**Southern Utah
Fuel Company**

**SOUTHERN UTAH FUEL CO.
MINE NUMBER ONE**

PROPOSED DRAIN FIELD

RE: Leachfield Modification
Convulsion Canyon Mine
ACT041/002, Folder No. 3
Sevier County, Utah

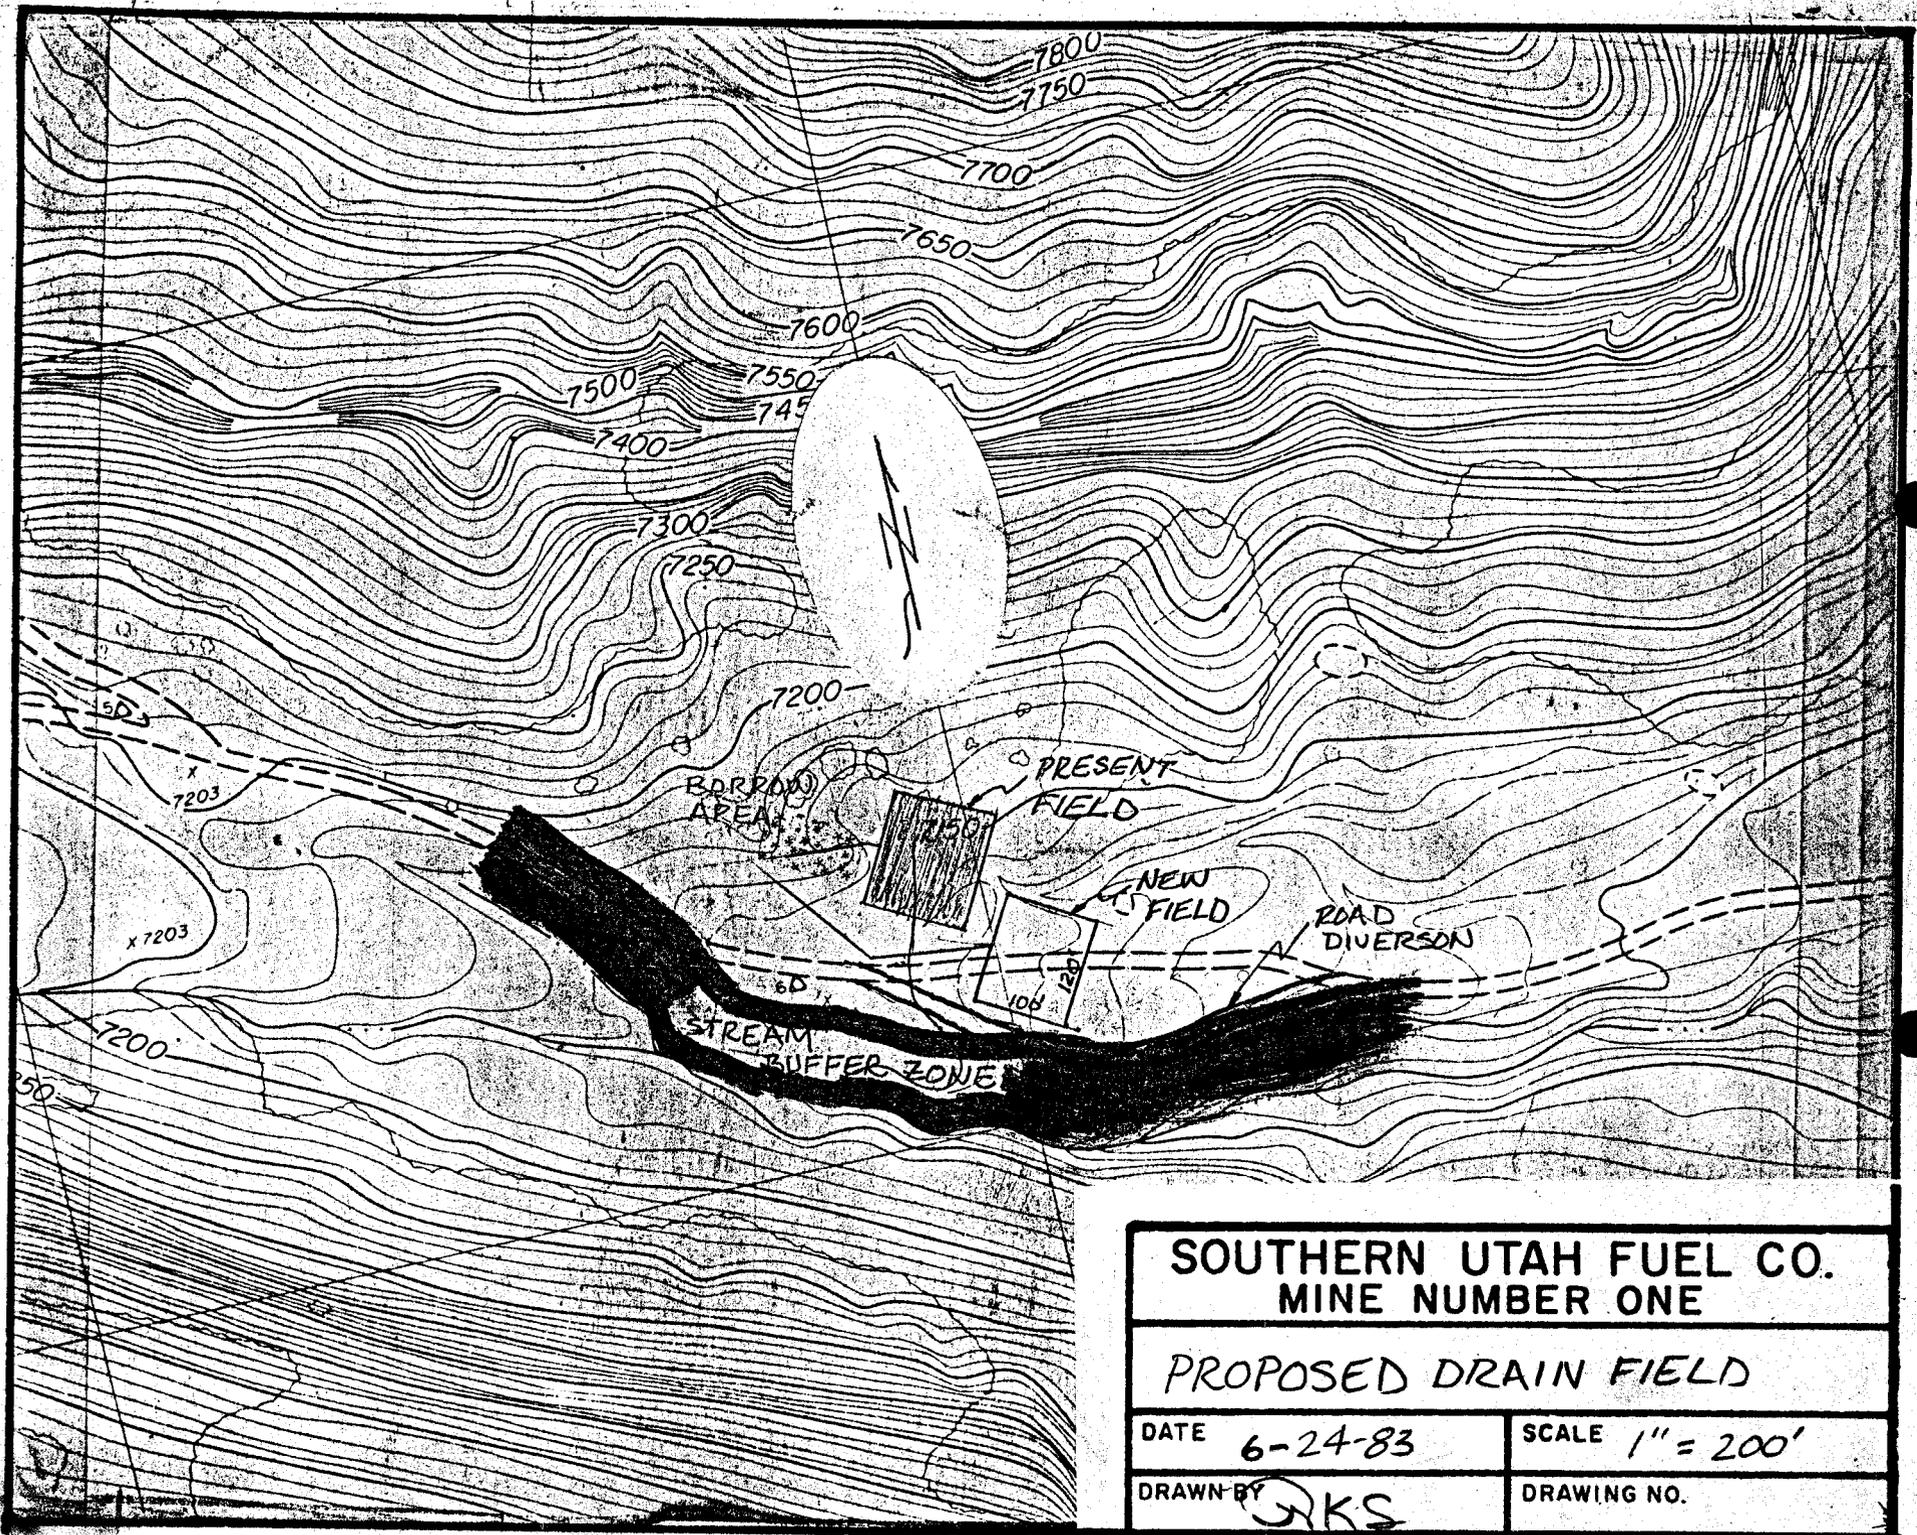
1. State Health must approve the plans for the drainfield and percolation tests must meet minimum criteria.
2. No disturbance may occur within 75 feet of the stream bed.
3. Topsoil must be stripped from the new road and drainfield areas and any borrow areas and either stockpiled or used to reclaim previously disturbed areas.
4. Reclamation seed mixes for the old drainfield, new drainfield and any borrow areas used must be submitted. Any permanent revegetation practices must comply with the requirements of UMC 817.111-.117.
5. If borrow areas are used, they must be indicated on a map. The volume of borrowed material must be reported in cubic yards, along with the amount of surface disturbance that will need to be reclaimed in these areas.

Southern Utah Fuel Company requested State Health approval of the drainfield on June 30, 1983, and plans to install the drainfield only after their approval. No disturbance is planned within 75 feet of the stream bed by either the new drainfield or the relocated jeep road.

SUFCo plans to strip the topsoil from the new drainfield area during construction and redistribute it across the new drainfield area during the revegetation process which will take place before January 1, 1984. Topsoil from the adjacent borrow area will be used to reclaim the old drainfield and the borrow area. The seed mixture used for revegetation will be the mixture specified by the Forest Service consisting of:

The borrow area is shown on the attached map. The total borrow material is expected to be about 900 cubic yards. This borrow material will come from an area roughly 50'x100' immediately west of the present drainfield installation.
